Hi-Fi Products
Service Bulletin

Model: TA-AX311/AV411

No. 253

Subject: Display Failure

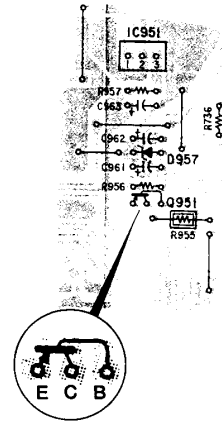
The unit is functional, but the display does not light. Q951, R955 and D957 should be tested for proper functionality. In most cases, Q951 will develop a problem from being over-driven and will sometimes cause R955 and/or D957 to develop a problem.

Solution: Check R955 & D957 and replace with parts listed in the Service Manual if necessary. Replace Q951 with the part number shown in the chart below:

NOTE: Be sure to follow the correct orientation of the new component when installing.
